## D/A Converter 1.949.688.00

## Vista Service News July 2005

## Vista Service News November 2005

**Vista 7 Center Frontboard (Bottom) 1.949.125.00**

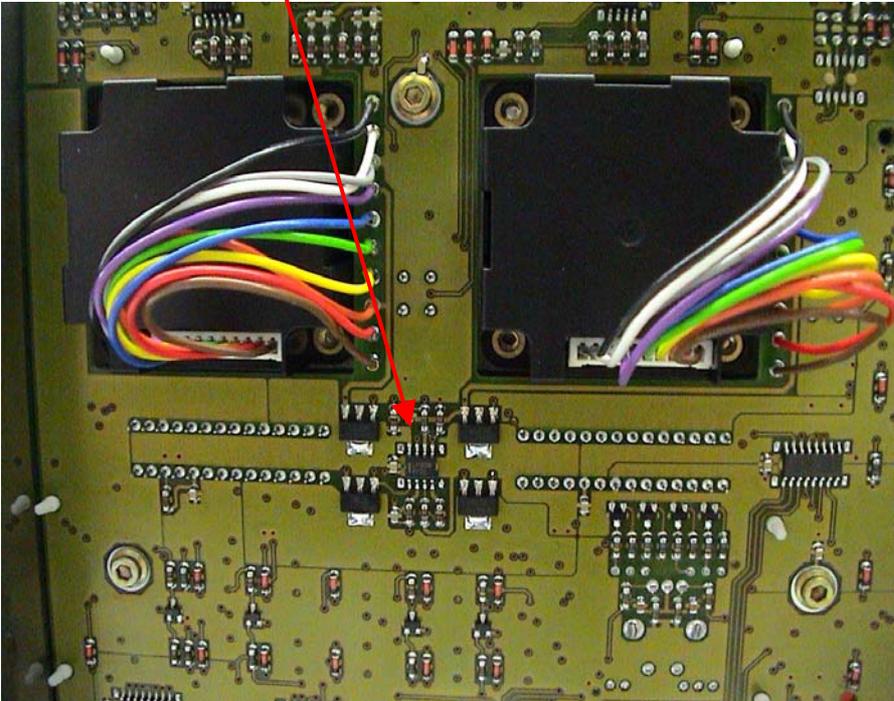
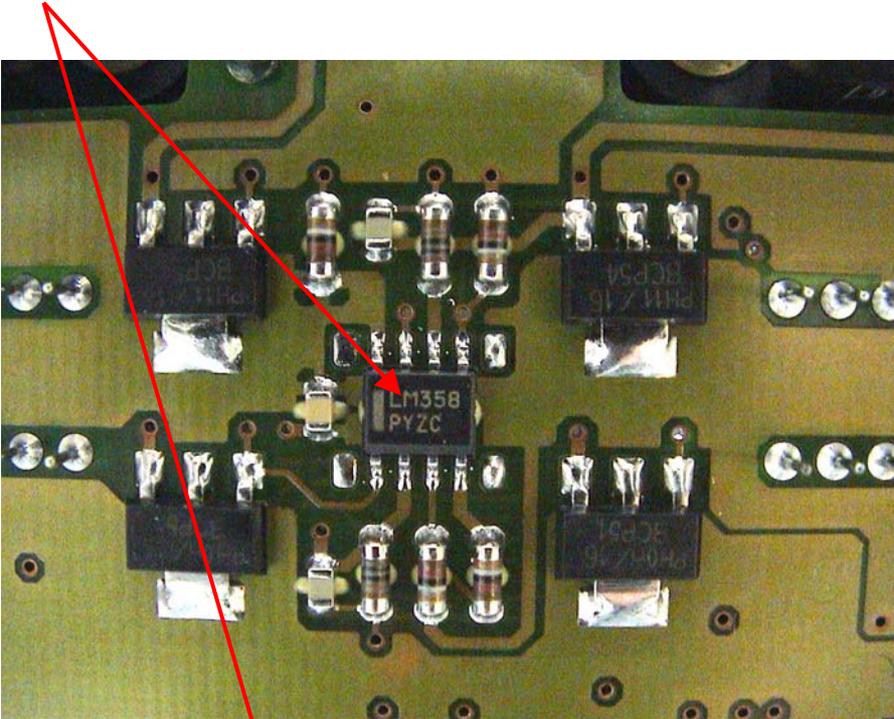
Modification 16.7.2002 (to Index "A")

IC 16 : TL062 replaced with LM 358 D.

(plus 2 x 100nF between AGND and Chassis)

## Redundant Supply of Red. Distribution Board 1.949.152.00

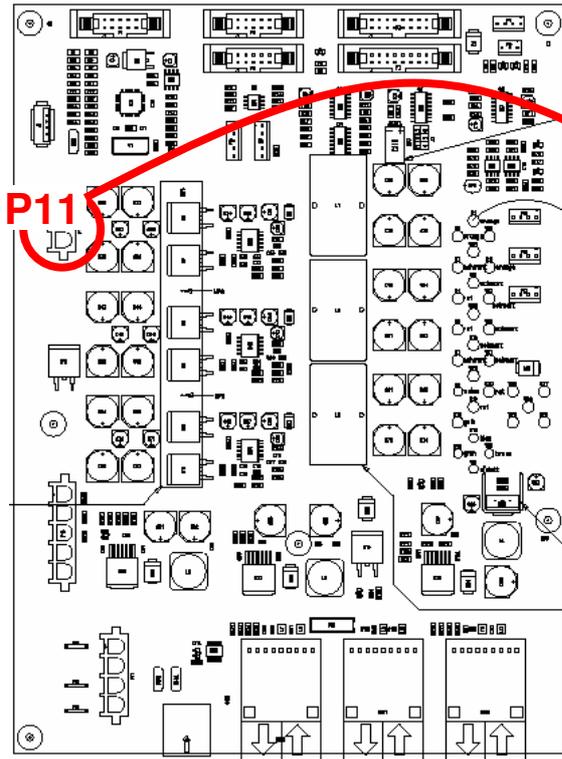
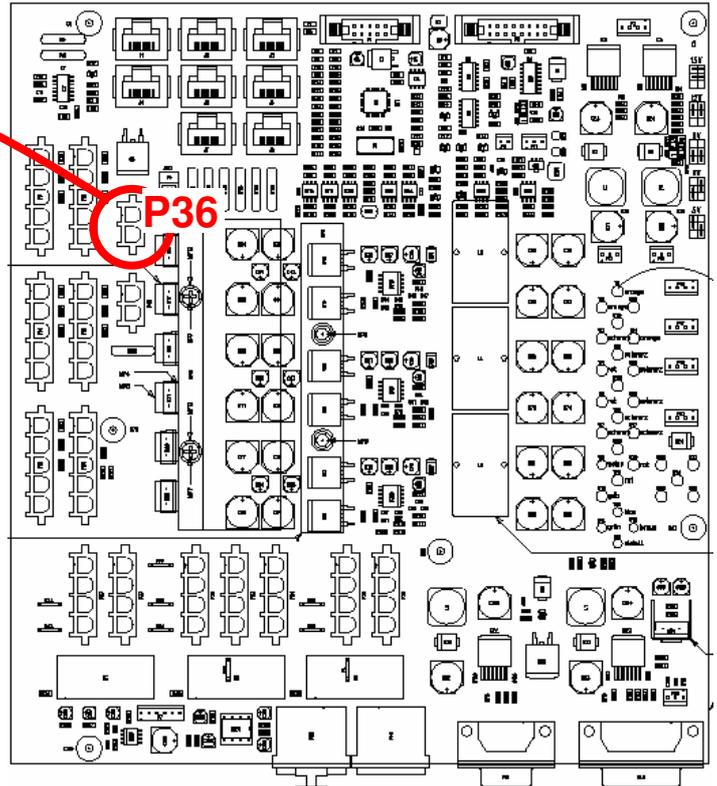
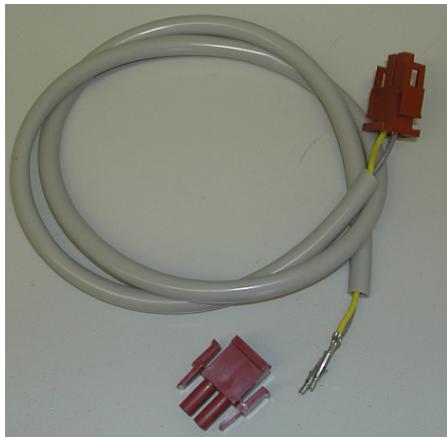
The redundant PC of the Vista 8 is currently supplied from a single supply. In case of a defect supply of the redundant PC, not only the redundant system would fail, but also the main PC because signals are switched on the redundant distribution board.

The following connection with the main distribution board (1.949.150.81) provides a redundant 24V supply for the 1.949.152.00 board as well for the whole redundant PC.

**Installation Note for Cable 1.949.020.93 :** For easier installation it is recommended to mount the second connector after the cable is in place. The wiring is 1:1 (pin 1-1 and 2-2)

Replacement of the critical capacitors on Vista Motherboard (EPoX EP-3PTA, Studer Part No 89.20.1122)

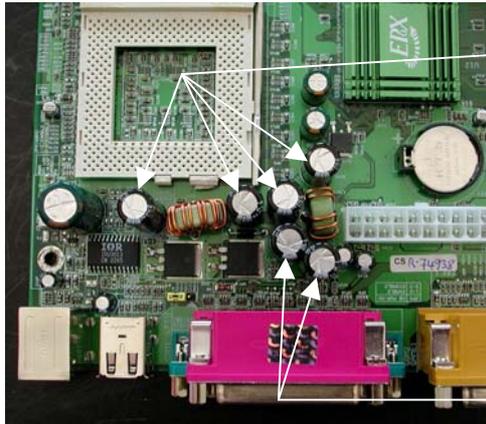
We did recently identify 3 boards in Vista systems (shipped at different dates) which showed the symptom with domed capacitor tops (see picture at left). As a result of the dramatically reduced value of these capacitors (part of the on-board DC-DC converter) the PC did not start anymore.

2200 uF  
6.3V / 105 °C

1500 uF  
6.3V / 105 °C

The indicated capacitors (1500 and 2200 uF) should be replaced with high quality components with the same specifications. The Studer replacement kit includes 6 capacitors of 2200 uF for replacement of the original 1500 and 2200 uF ones.

### Replacement of the critical capacitors on Vista Motherboard (EPoX EP-3PTA, Studer Part No 89.20.1122-E)

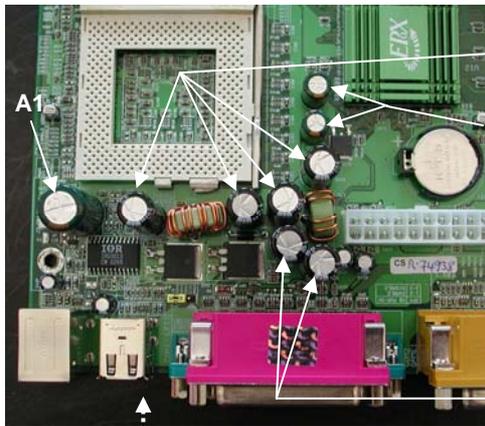
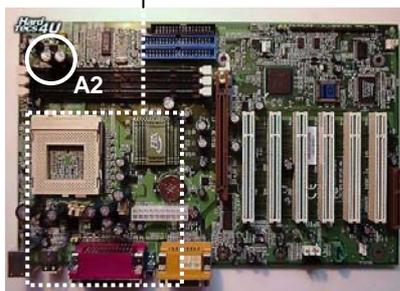
We did identify some boards in Vista systems (shipped at different dates) which showed the symptom with domed capacitor tops (see picture at left). As a result of the dramatically reduced value of these capacitors (part of the on-board DC-DC converter) the PC did not start anymore.

2200 uF  
6.3V / 105 °C

1000 uF  
6.3V / 105 °C  
(replace both with a single 2200 uF C)

1500 uF  
6.3V / 105 °C

The indicated capacitors (1000, 1500 and 2200 uF) should be replaced with high quality components with the same specifications. The Studer replacement kit includes 7 capacitors of 2200 uF for replacement of the original 1000, 1500 and 2200 uF ones (7 x 10.597.680.05)

- 1 capacitor 3900 uF (see A1)  
-> with 10.597.680.06 (3300uF)
- 2 capacitors near RAM module (see A2)  
-> with 2 x 10.597.680.05 (2200 uF)
